The Instrument Shop
Work Submittal Sheet
027 Lauritsen

Project Title: OFI - EQ Stops FOR MAGNETS Date: 23 August 2013

Drawing Ref # D0900778

Sketch (use the back if necessary)

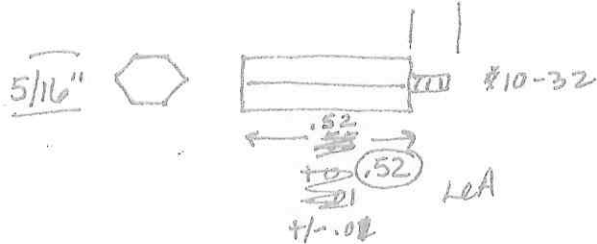
1) SEE DRAWING RED-LINES OF D0900778-V3 FOR MODIFICATION TO 6 MAGNET ATTACHMENT PLATES.

CHANGE VERSION NUMBER ON PARTS FROM 'V2' TO 'V3'.

2) ORDER ~~McMASTER-CARR~~ PART NUMBER 94035A535: ~~18-8 Stainless-Steel Precision Hex Socket Shoulder Screw, 1/4" Shoulder Diameter, 3/8" Length Shoulder, 10-32 Thread.~~

QUANTITY = ~~30~~ *20*

CUT THREADS OF SHOULDER SCREWS -
LENGTH = 0.125" +0/-.01
